FROM : Application: 1 Chesterford Gardens, London, NW3 7DD, (2020/1502/P)
 DRAWINGS SUBMITTED:

Project stage	Scale	Sheet
Report	1:1	A2
Drawing Nr	02	
Description	Note on Planning 2020/1502/P	
Edition - 1	Change num	
	0	
File name	Date	
Report 3.dwg	30 Mar 2021

Project Address
23 Reddington Rd. NW3 7QX

Drawing No.AP01 (Rev. B)

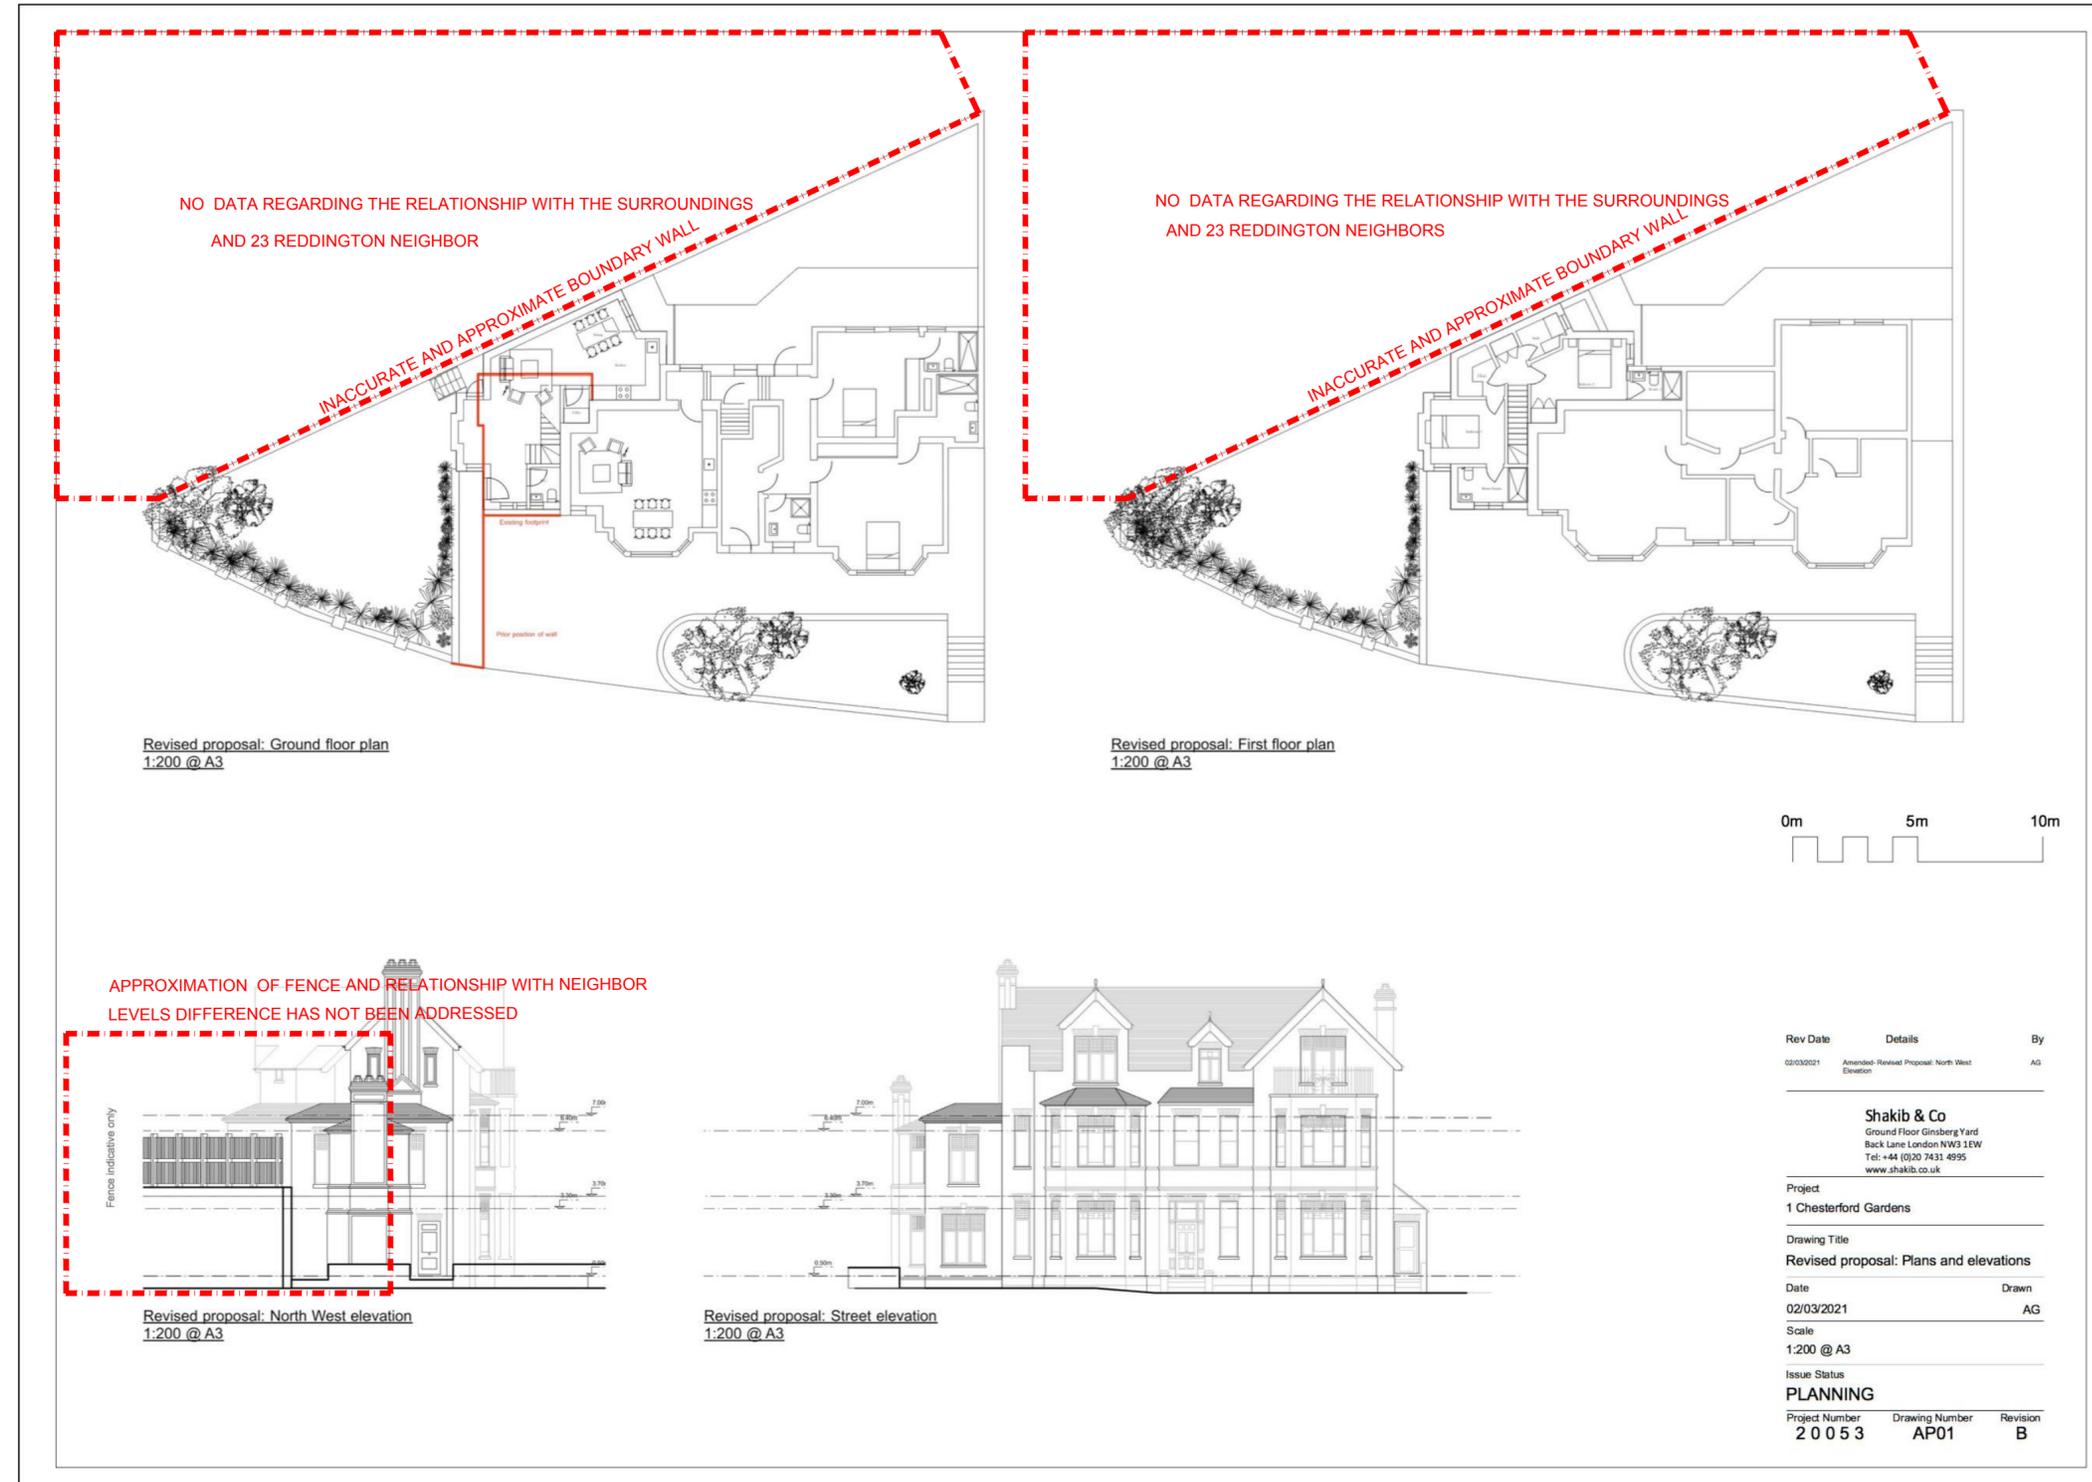
The level differences are still not addressed.

Drawing No.003

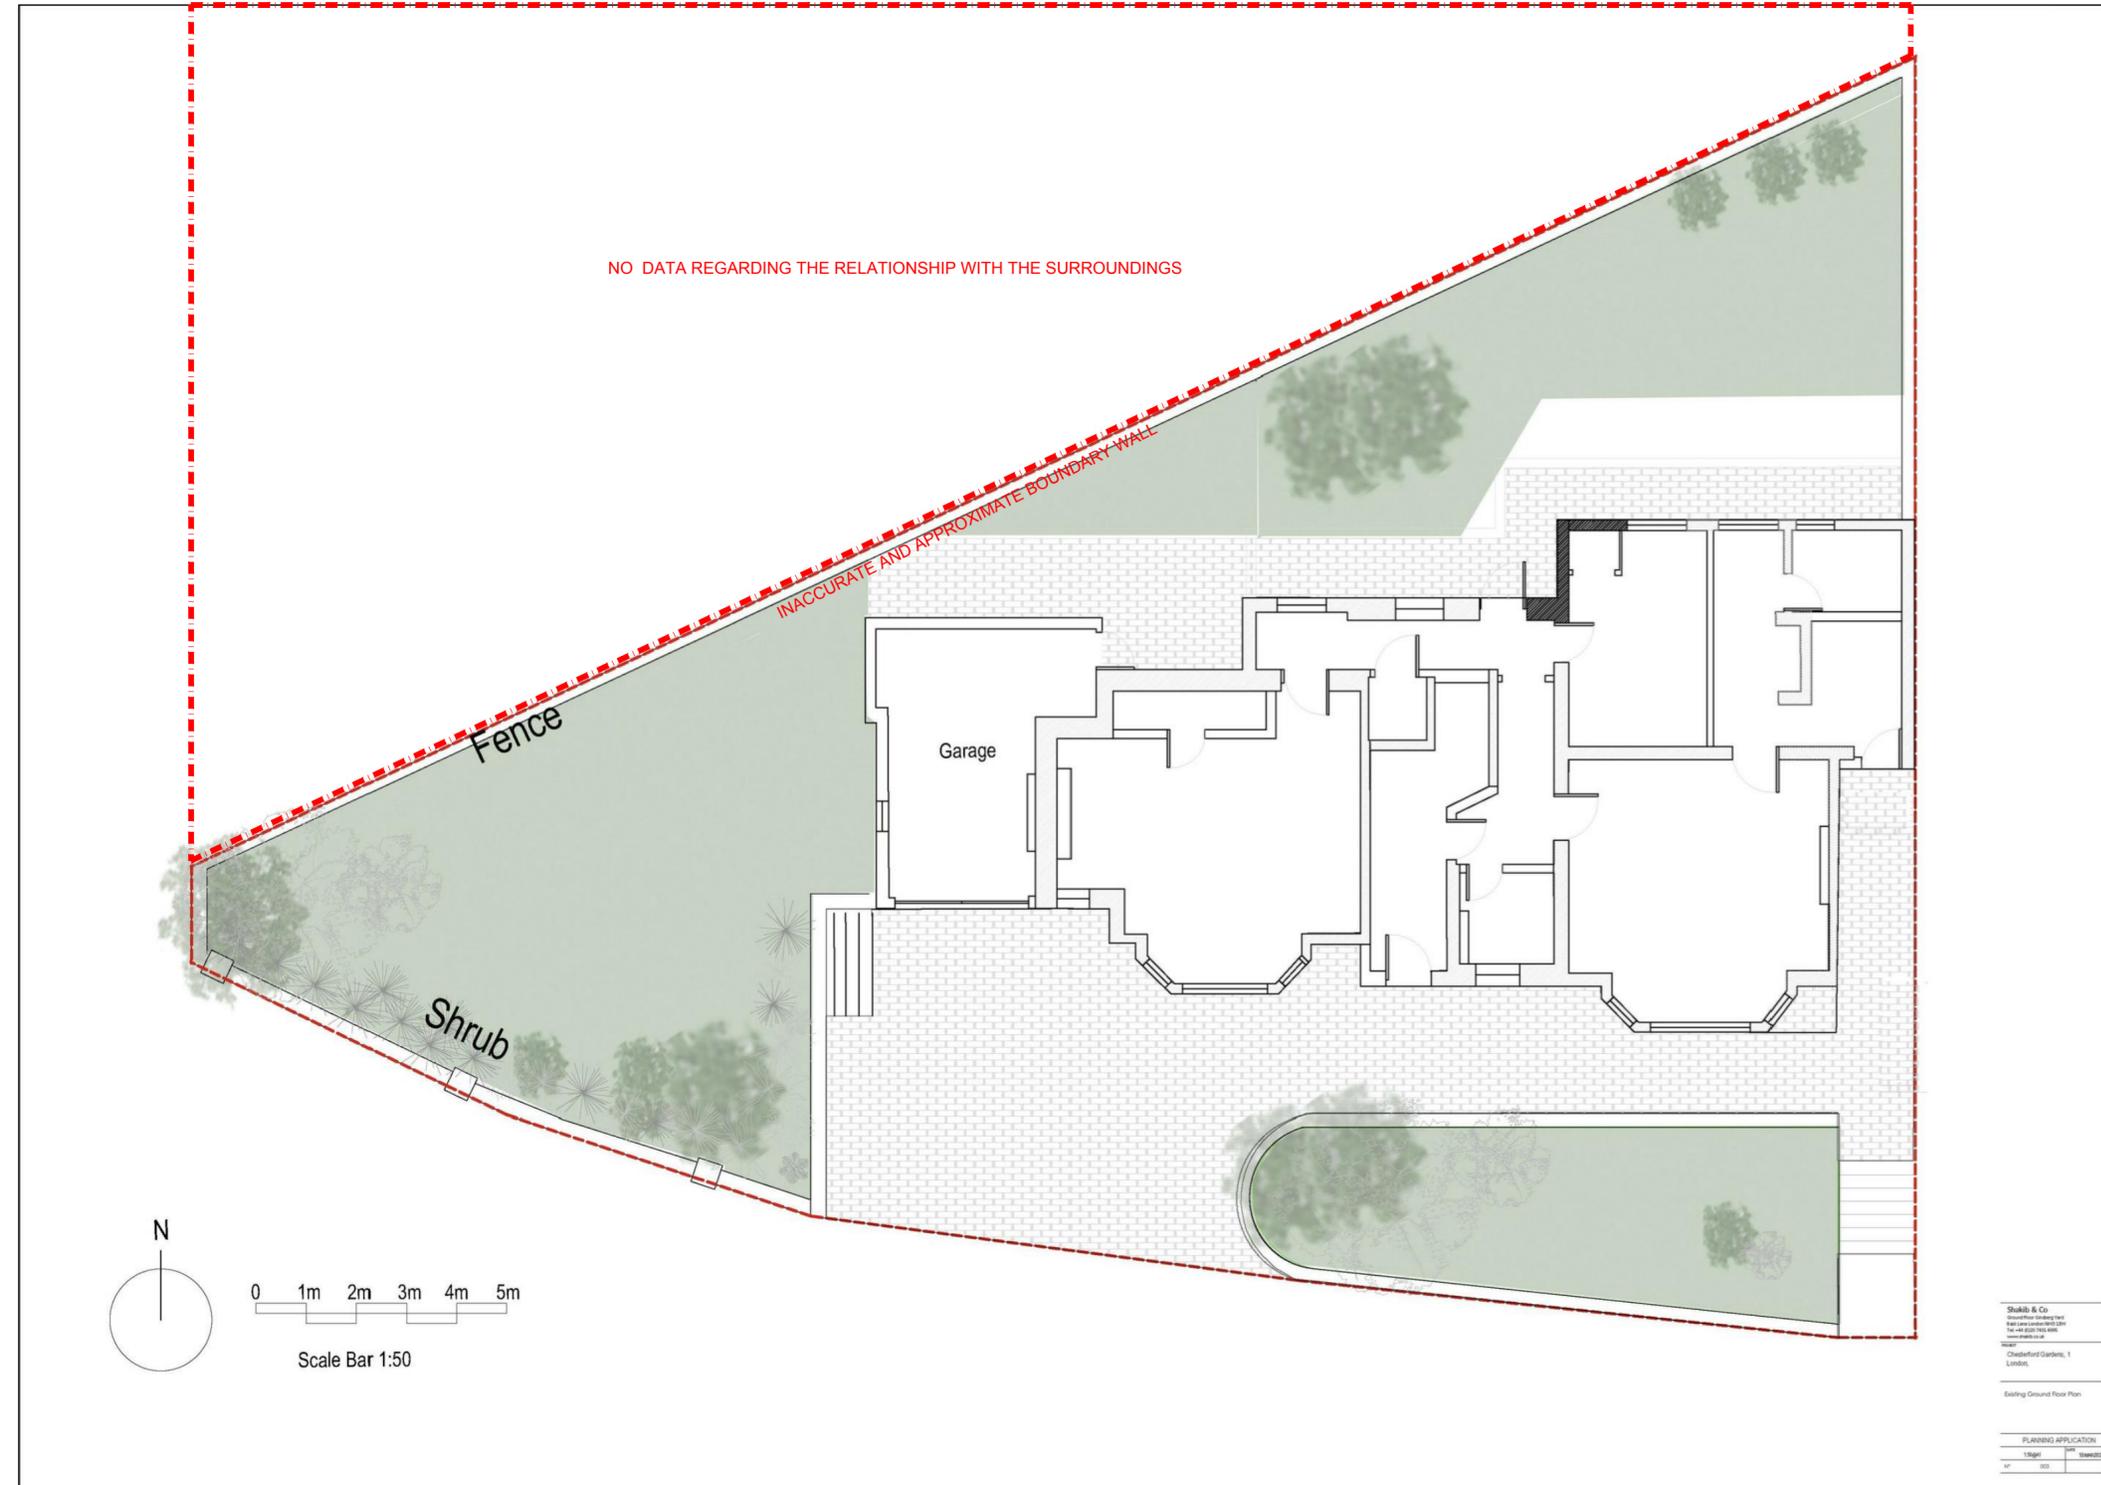
Inaccurate boundary wall locations between 23 Redington Road and 1 Chesterford Gardens.
